Plan Change 58: Avenue Business Park  
Further Traffic Information

This letter provides responses to matters raised in the traffic peer review letter prepared by Gray Matter dated 16 March 2023. This letter is intended to be submitted as part of a broader response to the further information request from Matamata-Piako District Council (MPDC) dated 21 March 2023 for Plan Change 58 (PC58) which identifies the need for the Applicant to respond to matters raised in the Gray Matter peer review (amongst other items).

Project: ROUNDABOUT LAYOUT PLAN

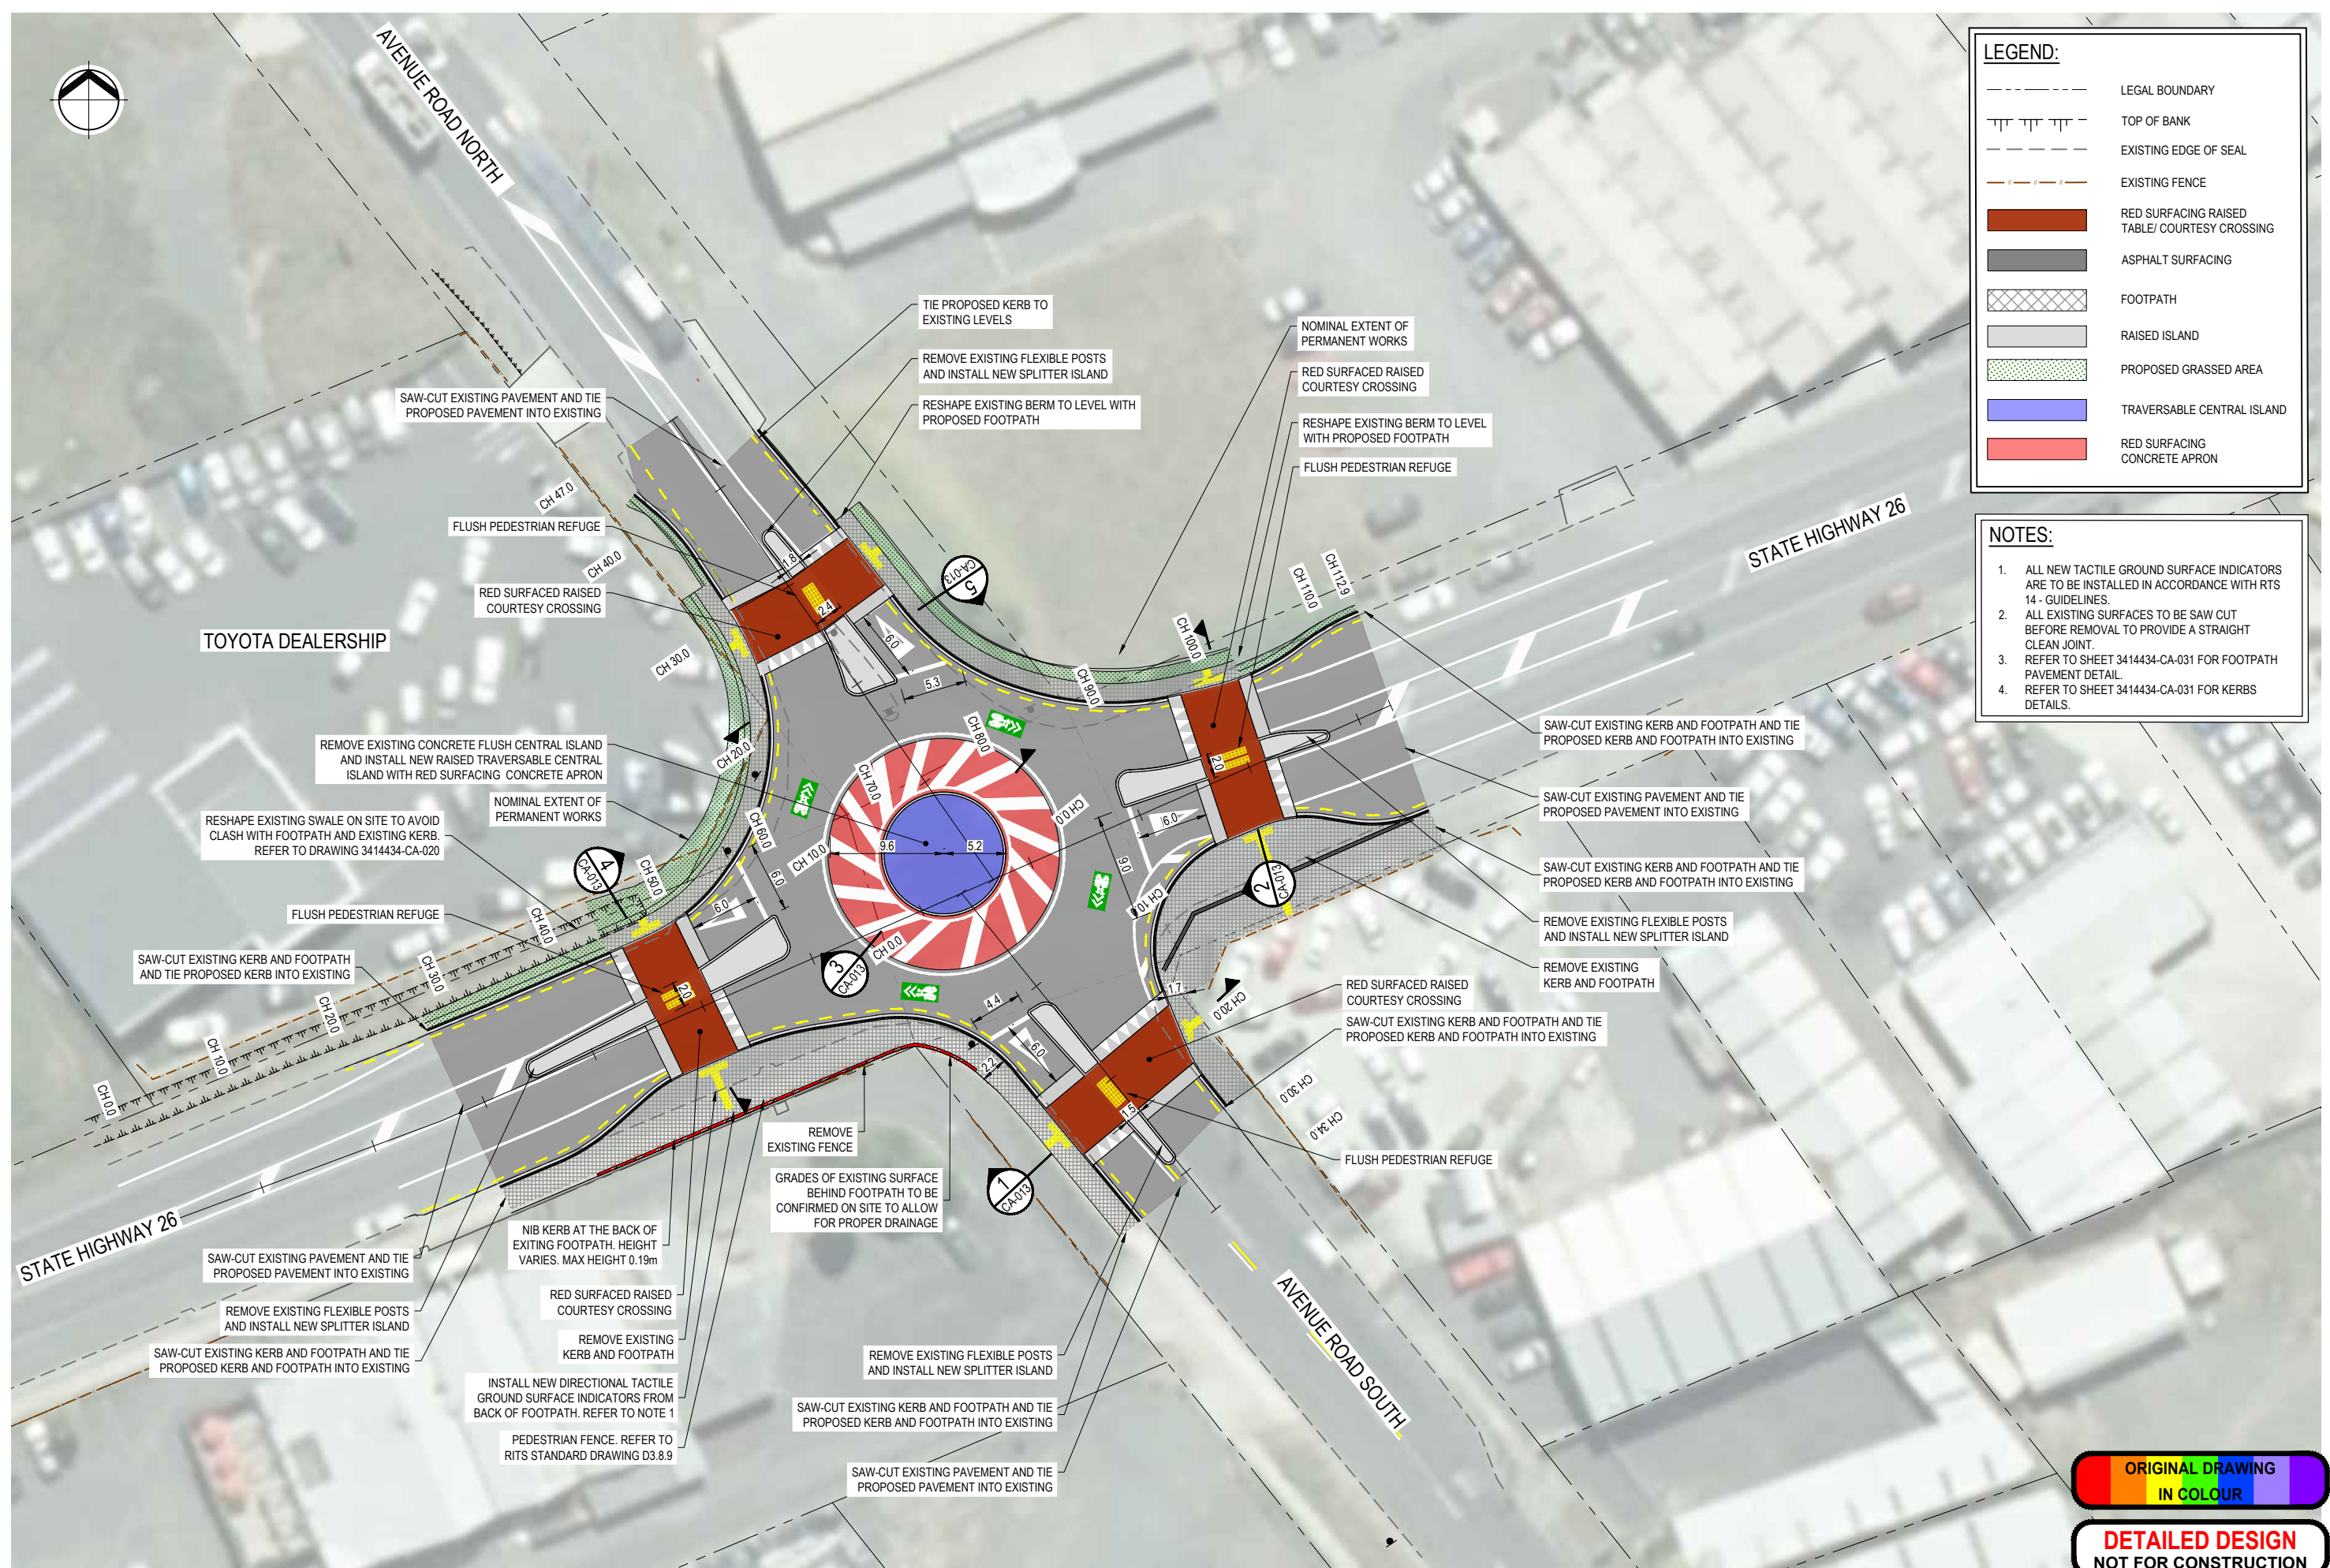
4.5	Potential effects on the state highway network	<p data-bbox="577 742 1413 912">Waka Kotahi has confirmed they are constructing a roundabout at SH26/Avenue Road and they are comfortable with the plan change proposal. They will have an opportunity to make a submission should they wish to do so. The Applicant will check with Waka Kotahi where this upgrade is at and if intersection assessment data is available.</p> <p data-bbox="1447 742 2119 837">Waka Kotahi's design plan for this roundabout is attached to this letter. Waka Kotahi has advised that no intersection assessment data is available.</p>
